**RE: PROPOSED REDEVELOPMENT
OF HURSTVILLE PRIVATE HOSPITAL**

1. As requested, we are writing to set down our responses to matters raised by the Department of Planning following the exhibition period for the above development. We have previously prepared a report¹ which was submitted with the Part 3A application.
2. In a letter dated 10 January 2013, the Department of Planning has raised a number of matters relating to transport and accessibility. These matters, and our responses, are provided below.

TITLE:
ACCESS TO NEW SITE LOADING BAY
OPTION 1

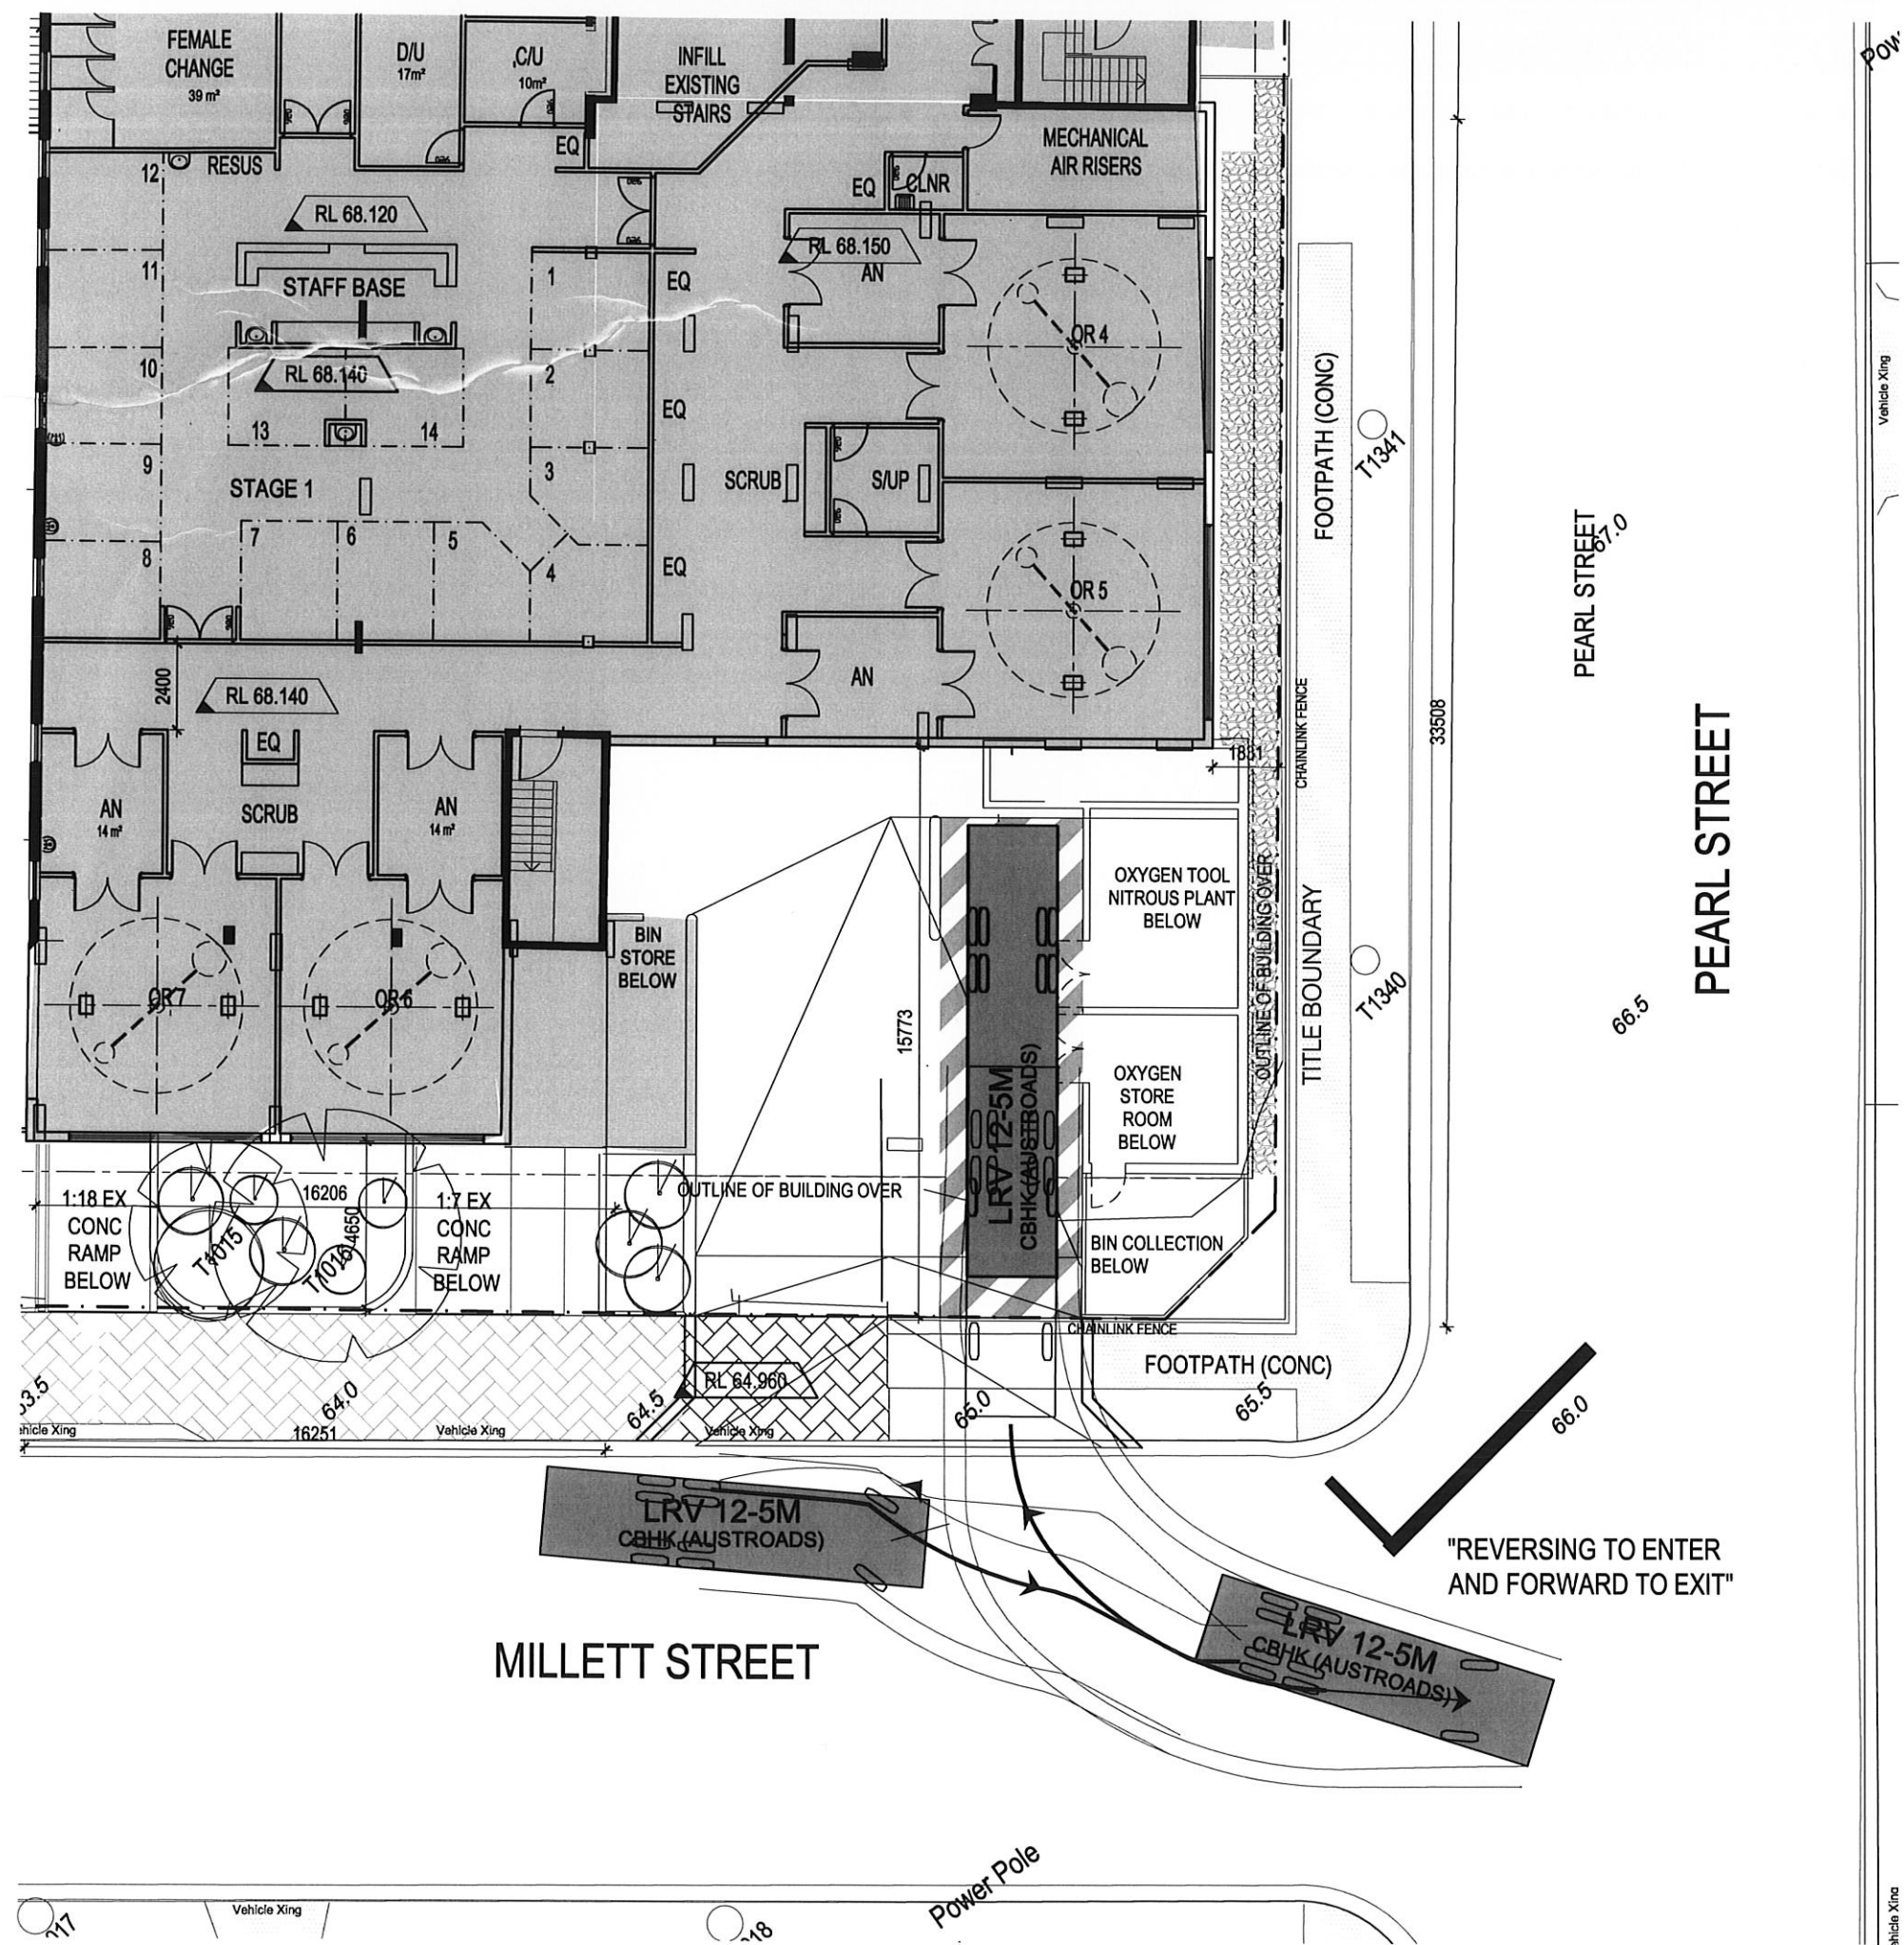
- *Provide more information about how the servicing of the proposed development is to be achieved and in particular, demonstrate how loading and unloading by vehicles is to occur in a forward direction only. If there is a need for reversing manoeuvres from Millet St, justify why the design cannot be amended to include forward only servicing and provide detailed documentation as to the frequency of any such servicing (including likely arrival and departure times and vehicle type) and that the frequency is in accordance with the Australian Standard for Parking Facilities by specific reference to relevant provisions.*
10. The first part of this matter is being addressed by the project architect. To provide for large service vehicles to enter and exit the site in a forward

7. Additionally, the driveway should provide for turns by service vehicles entering and exiting the development. Swept paths are attached in figures prepared by the architect (DA-083 and DA-084) show that the driveway will accommodate these turns.

15. It is therefore anticipated that there would be some two to four small to medium rigid trucks per day which may reverse between the site and Millett Street. The Australian Standard for Parking Facilities (Part 2: Off-street commercial vehicle facilities), AS 2890.2 – 2002, indicates that “regular service” (more than once per day) from a “minor road” (road carrying predominantly local traffic, such as Millett Street) should occur in a way that only one reverse manoeuvre occurs either to or from the street. The design provides for vehicles to enter and exit the site using one reverse manoeuvre, as shown in the attached drawings DA-083 and DA-084, prepared by the architect.
